Planning and Zoning Board Agenda October 13, 2020

SUBJECT: Site Plan – Hal Brady Recreation Center Maintenance Building: A request by Travis Hastay, P.E., of CHW, Inc., applicant and agent, for the City of Alachua, property owner, for consideration of a Site Plan to construct a $\pm 2,000$ square foot accessory structure (maintenance building) with associated stormwater and utility improvements on a ± 0.50 acre development area . Tax Parcel Number 03061-004-001 (Quasi-Judicial Hearing).

Planning & Community Development Department Staff Report

**RE: Hal Brady Recreation Center Maintenance Building (Site Plan)-
Development Review Team (DRT) Comments**

SHEET NO.: C1.00

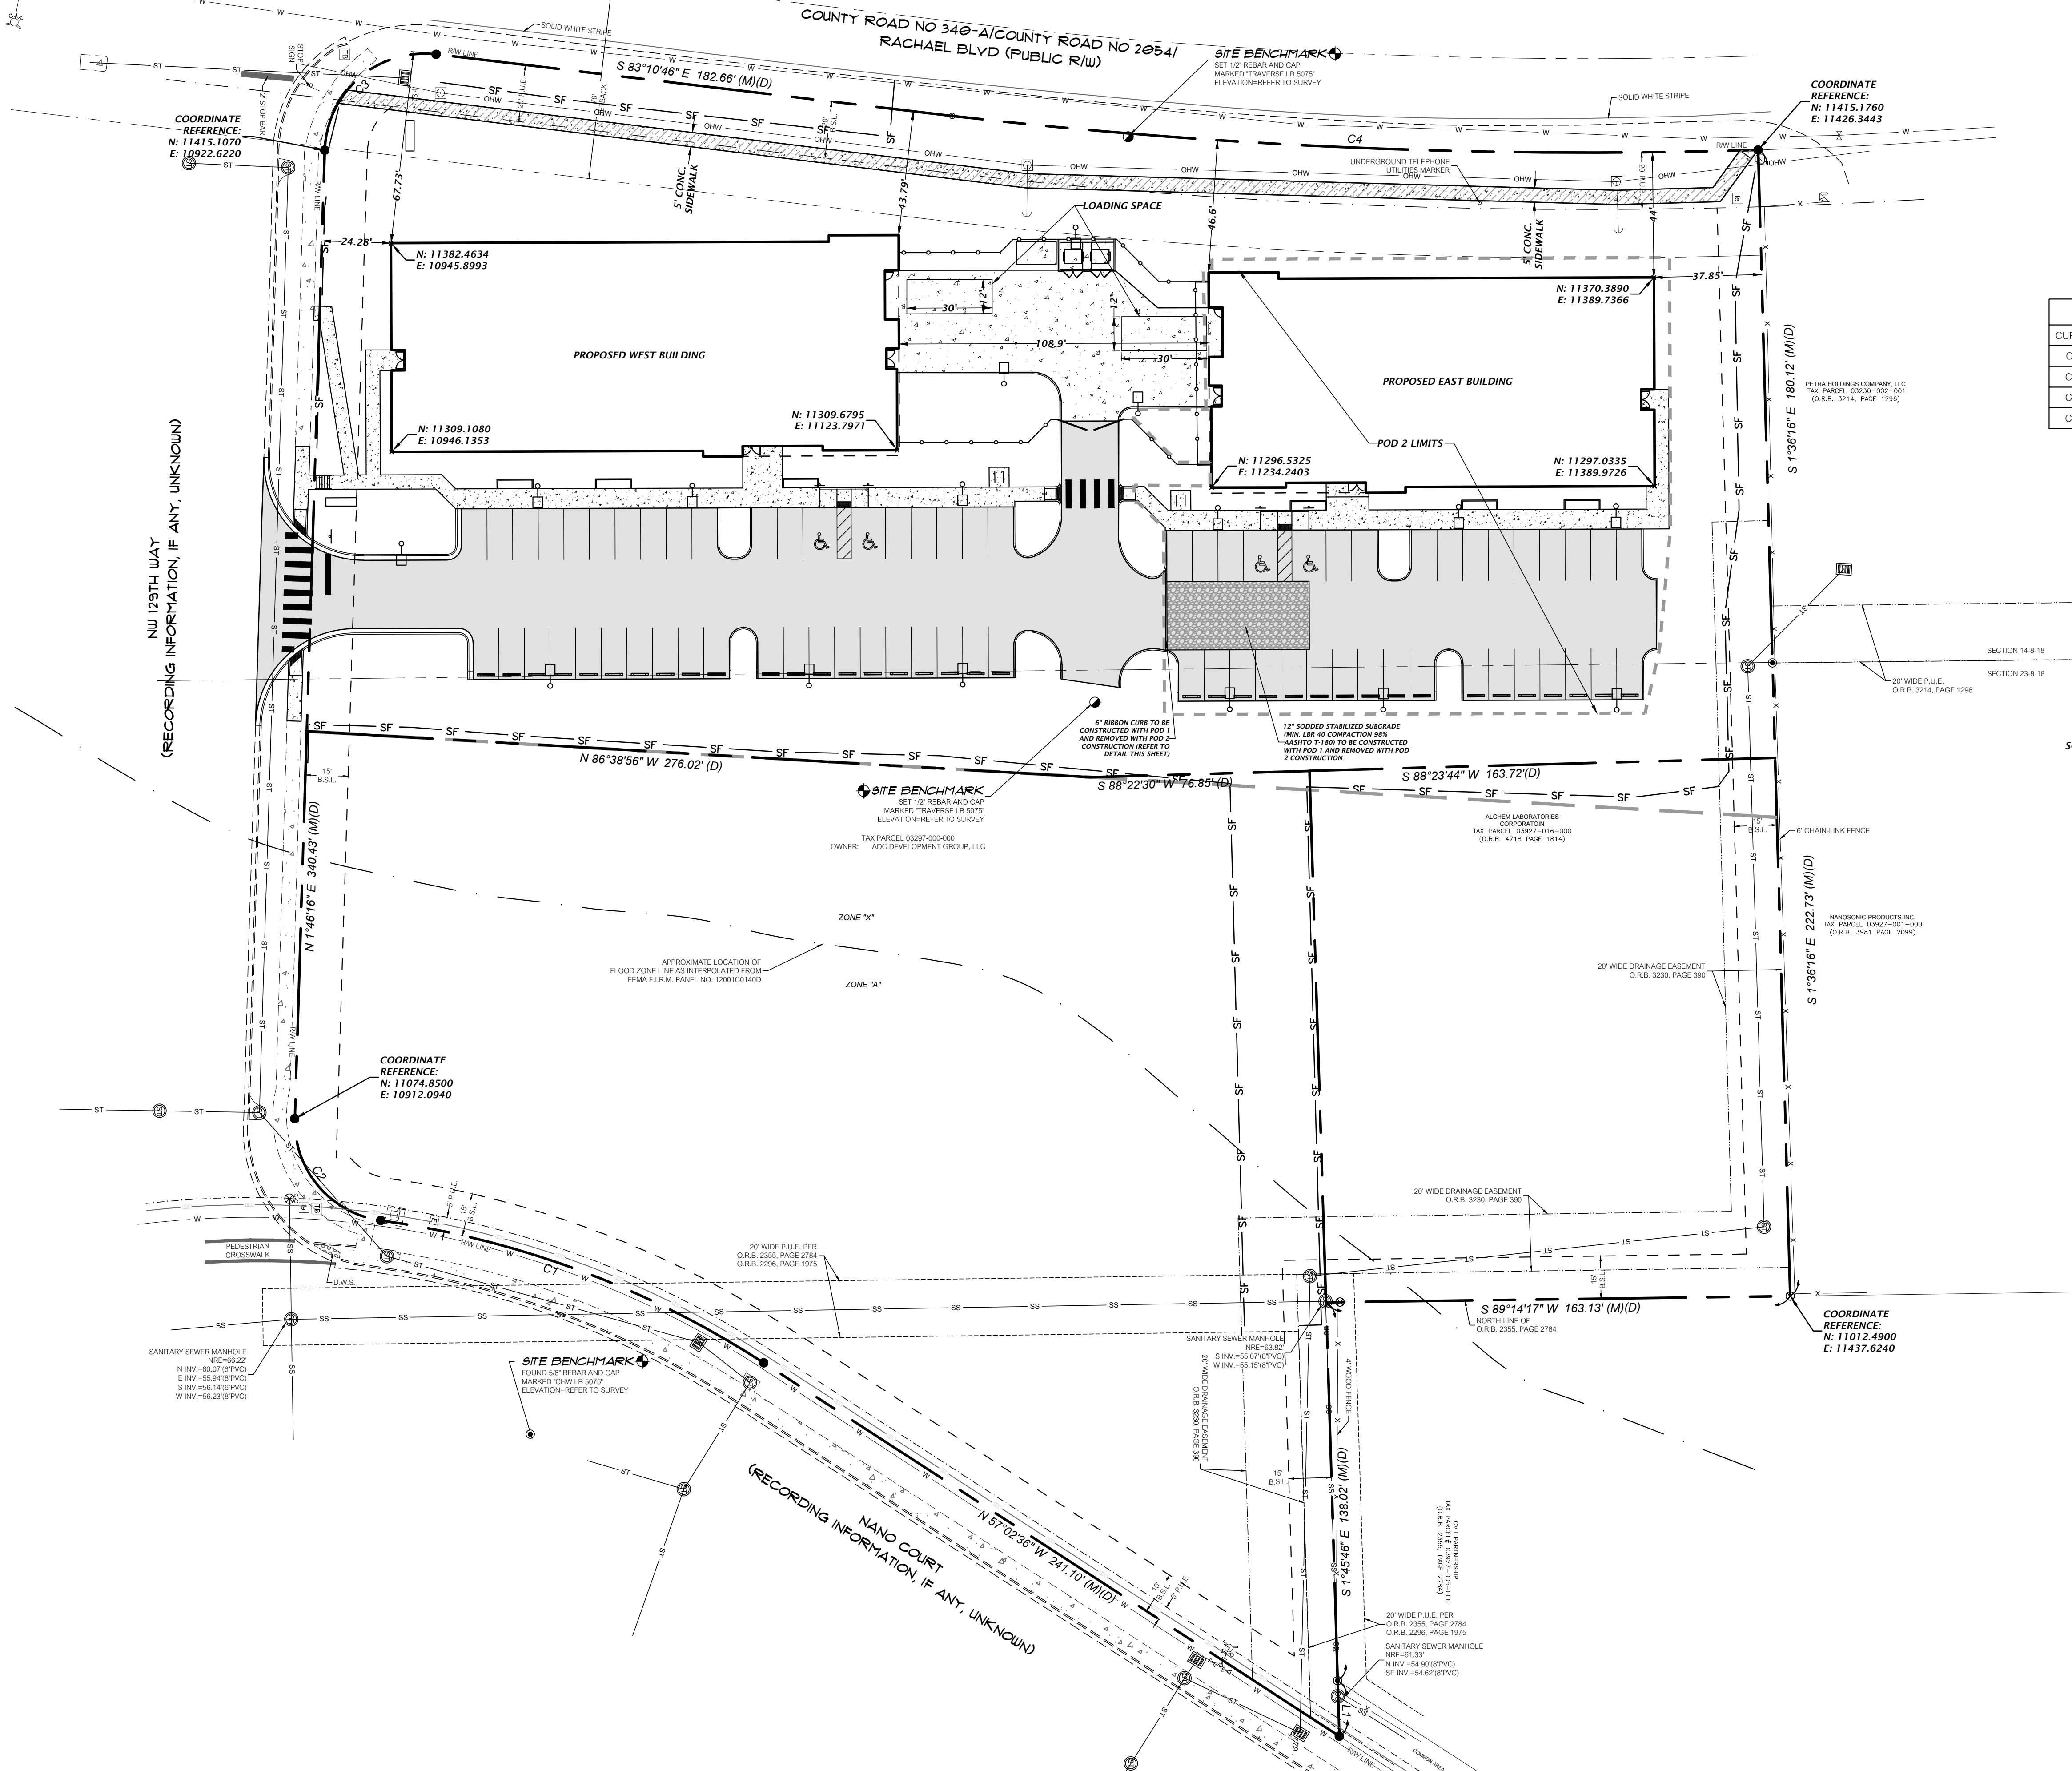
- **The site plans have been revised to indicate the boundaries and ownership of adjacent parcels. Please refer to sheet C1.00 for details.**
 - c. Sheet C2.31: Add detail number to the standard manhole detail.
